TECHNICAL RESOURCE DOCUMENT

EXTRACTION AND BENEFICIATION OF ORES AND MINERALS

PHOSPHATE AND MOLYBDENUM

MINE SITE VISIT:
IMC FOUR CORNERS MINE

Figure 5. Washer Plant Flow Diagram
(Source: U.S. EPA Field Note)

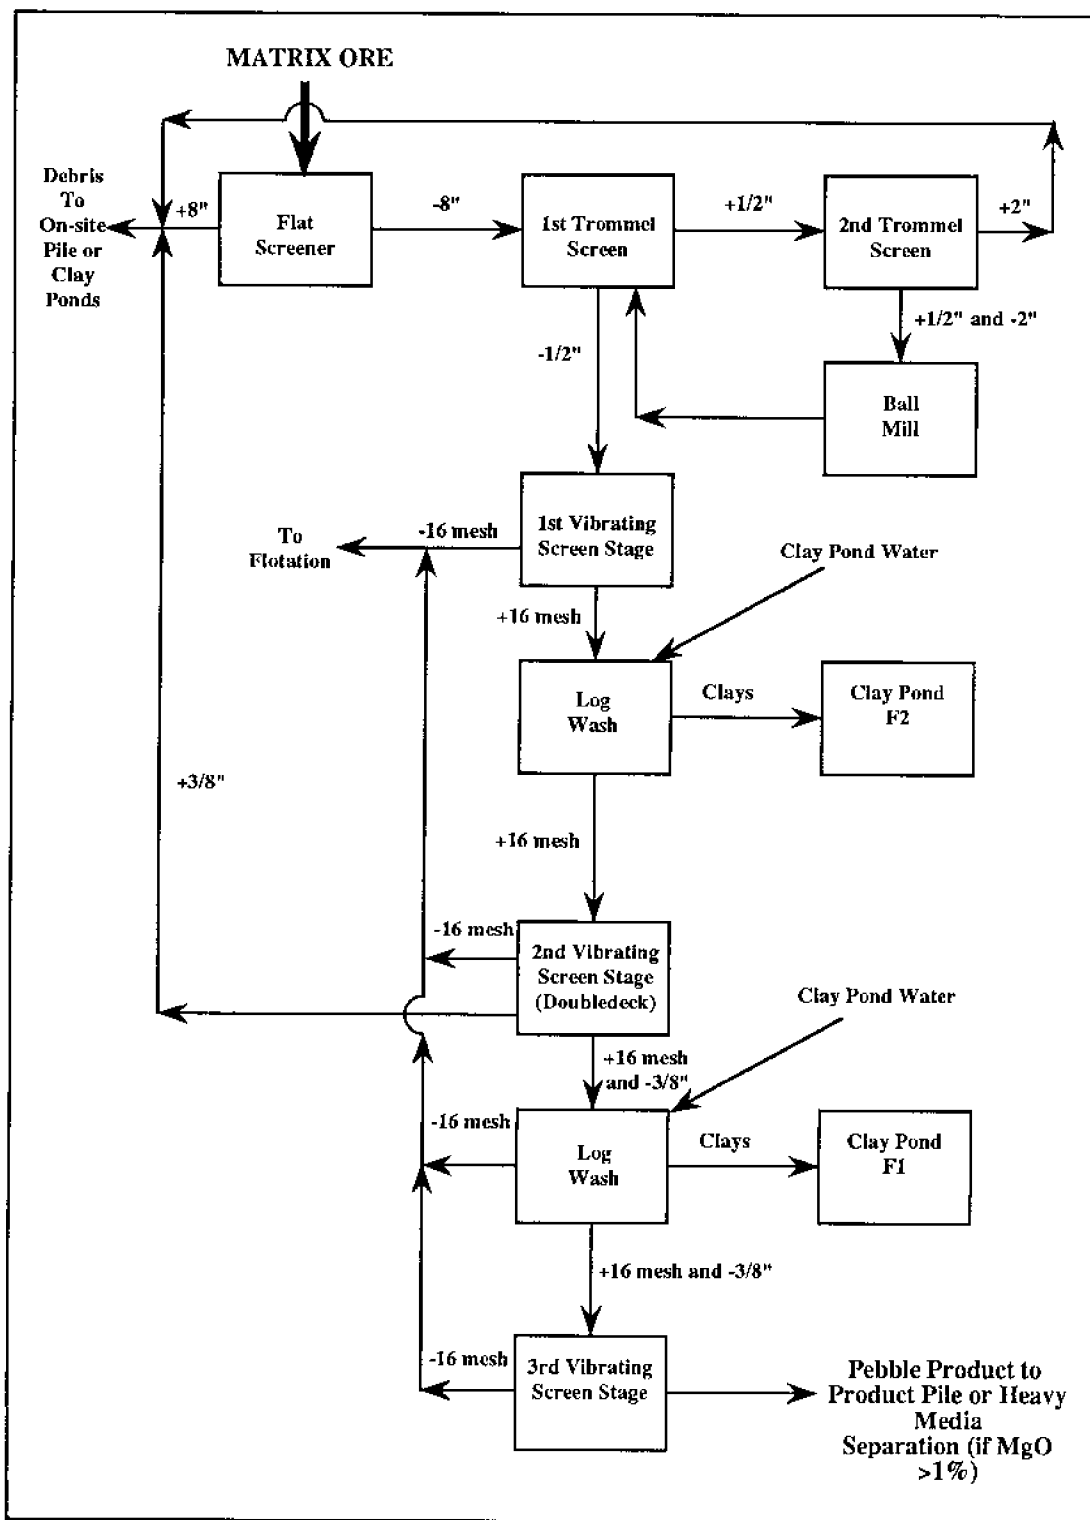
Page 16, Figure 5:

Replace this figure with the revised Figure 5 (attached). The original is not correct.

Figure 2: Cyprus Thompson Creek Site Map
(Source: Cyprus, provided at Site Visit)

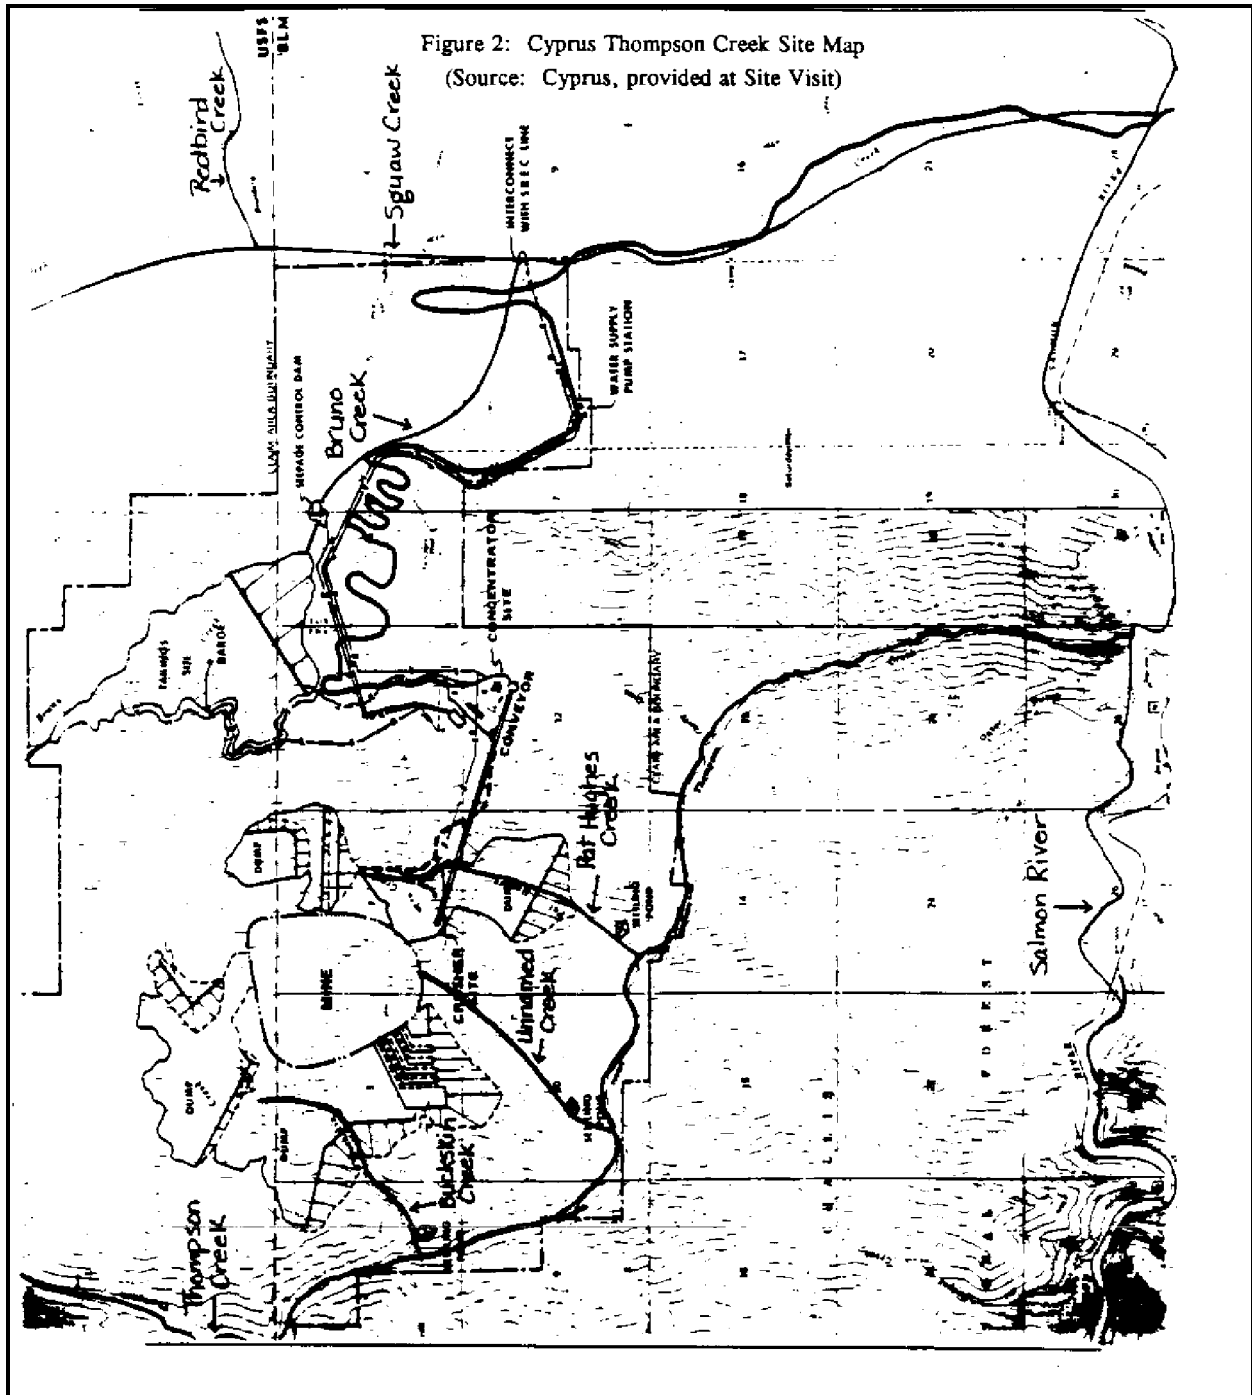
Page 5, Figure 2.: The figure shows a non-existing "unnamed creek" flowing from the pit to the Salmon River between Pat Hughes Creek and Buckskin Creek. It also shows a settling pond on this unnamed and non-existing drainage. This Figure should be corrected.
